Date	2014.05.05
Objet	Safety warning! n°2014/01/E2-E2L-A3

Reserve parachute handles for the EVO XC2, SKYPPER, SHAMANE and SHAMANE FR

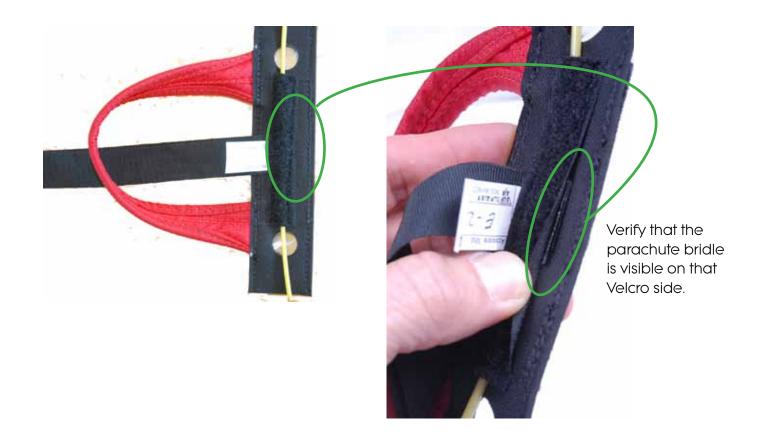
The bridle connecting the handle to the POD must be held in place with the Velcro strip two stitched lines.

A few handles were assembled without the bridle reaching the second stitched line. To check the handle, you must look underneath the Velcro strip and see if it is visible under the stitched line.

If the handle conforms then, reposition it has it initially was.

If the handle does not conform: you must contact your nearest SUPAIR dealer, or SUPAIR representative in your country, or SUPAIR-France directly, at sav@supair.com to proceed with the free of charge reserve parachute handle replacement.
